Application for Licence Amendment

Part V Division 3 of the *Environmental Protection Act 1986*

Licence Number	L9037/2017/1
Licence Holder	Process Minerals International Pty Ltd
ACN	063 988 894
File Number	DER2017/000318-1
Premises	Mount Marion Lithium Project Mining tenement M15/1000, M15/717 and on private land known as Hamptons Lease Area 53, portion of Lot 105 on Deposited Plan 40396, Volume 2668 Folio 420. As defined by the Premises maps attached to the Revised Licence
Date of Report	5 July 2022
Decision	Revised licence granted

Figure 1: Prescribed premises (shaded yellow) and Hampton Lease (unshaded)

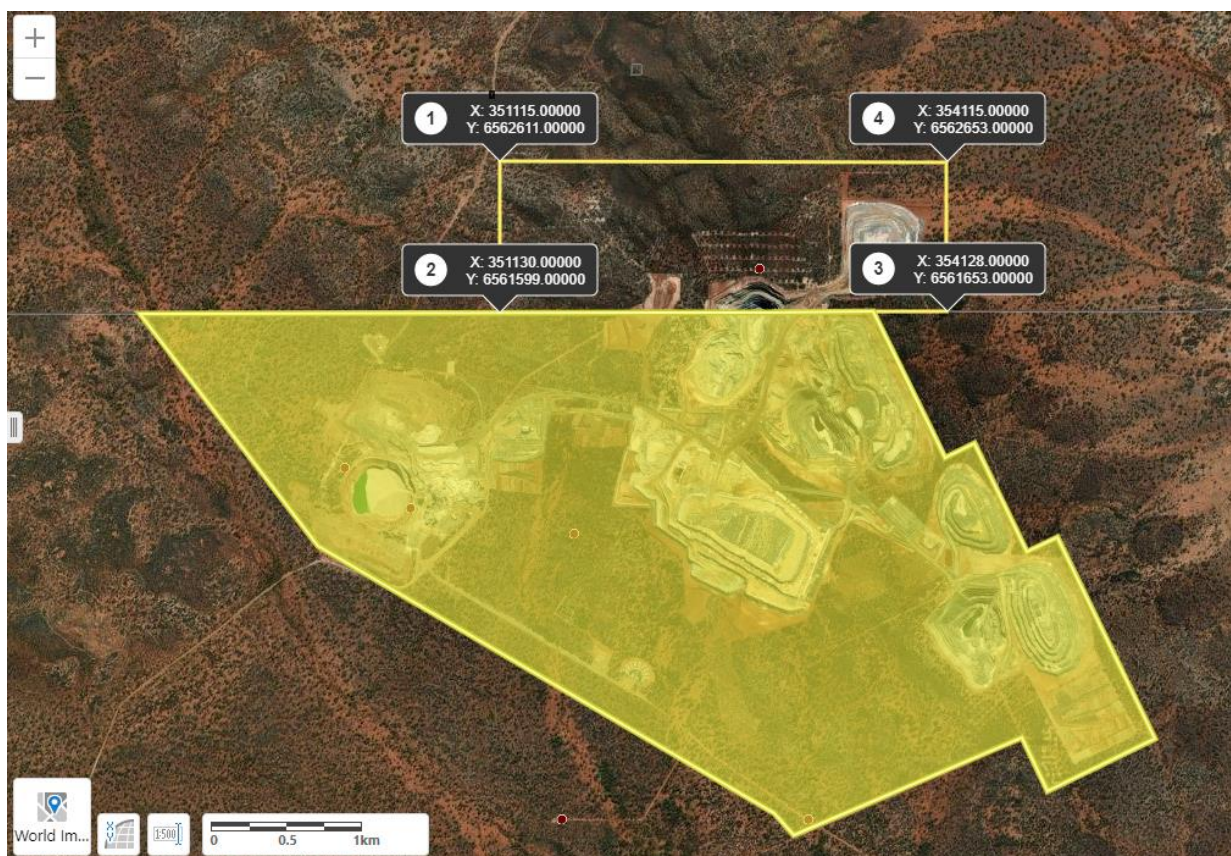
The Licence Holder has requested an alteration to the current boundary of the prescribed premise, expanding it north to include a portion of Lot 105 on Deposited Plan 40396, Volume 2668 Folio 420 (Hamptons Lease Area) as identified in Figure 1.

The increase in boundary increases the premises by 302.37 ha; and will facilitate mining activities in the North Pit. This activity has been approved under a development application through the Shire of Coolgardie (PA 12/2019) and Clearing Permit 8632-1.

The Delegated Officer has reviewed the relevant supporting documentation, supplied by the Licence Holder, and considers this change to be acceptable. Premises maps and tenements have been updated in the revised licence.

Figure 3: WRL landfill as approved by DWER and as constructed

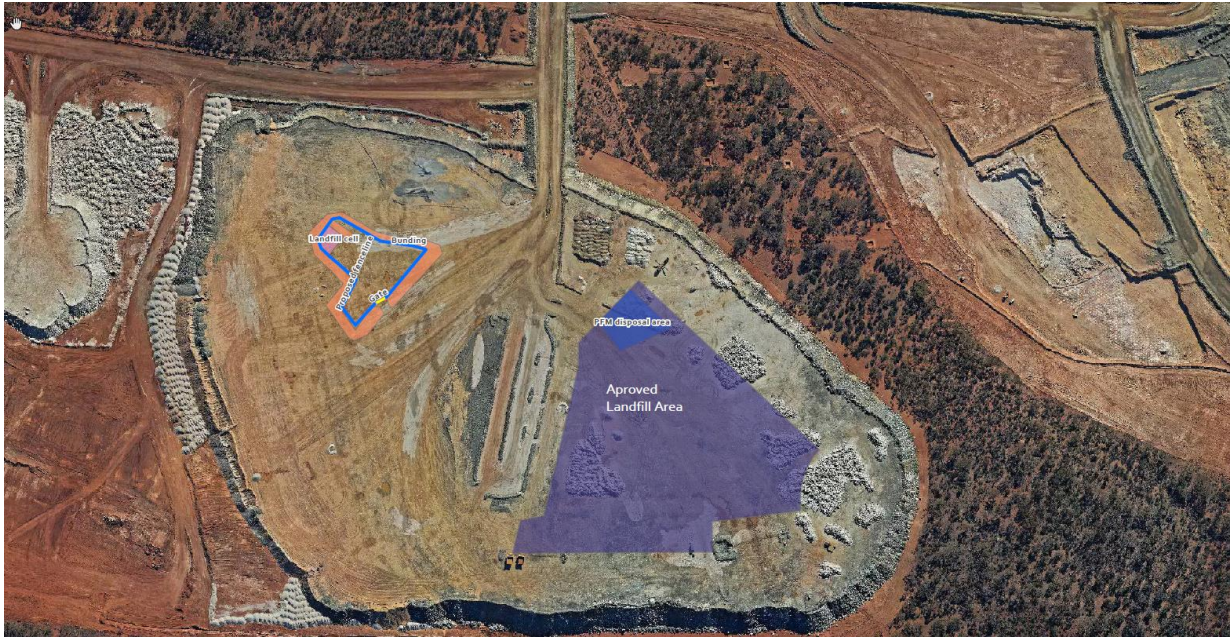
As reported in the Annual Audit Compliance Report in 2021, the final constructed location of the waste rock landform (WRL) landfill was 250 m to the west of the proposed footprint, see Figure 3.

The Licence Holder informed the Department that this was due to a change in site layout from original design plans. This non-compliance was reported to Industry Regulation and was investigated by Compliance and Enforcement and was deemed to be a minor variation to the licence conditions. The department suggested the Licence Holder correct and update the licence when next submitting a licence amendment application.

Figure 7: Mount Marion SAF wastewater treatment plant upgrade diagram

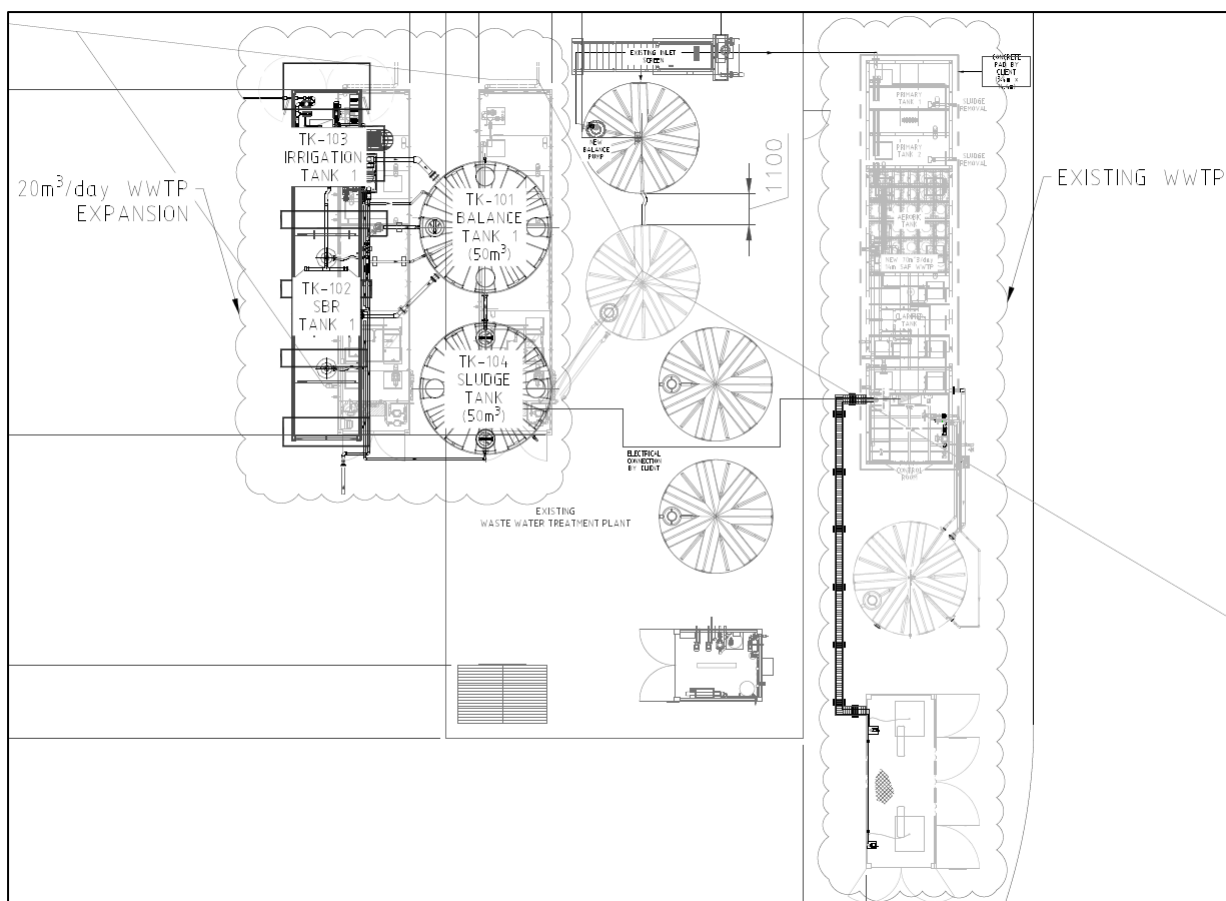
Due to expected increase in worker capacity at the Mount Marion Project, the Licence Holder has requested that WWTP capacity be increased from 70 m³ to 90 m³/day through the addition of a second wastewater treatment plant.

The new WWTP plant will sit in parallel to the proposed 70 m³ unit on site, and make use of infrastructure, piping and electrical networks that remains once the existing 35 m³ units are removed (Figure 7).
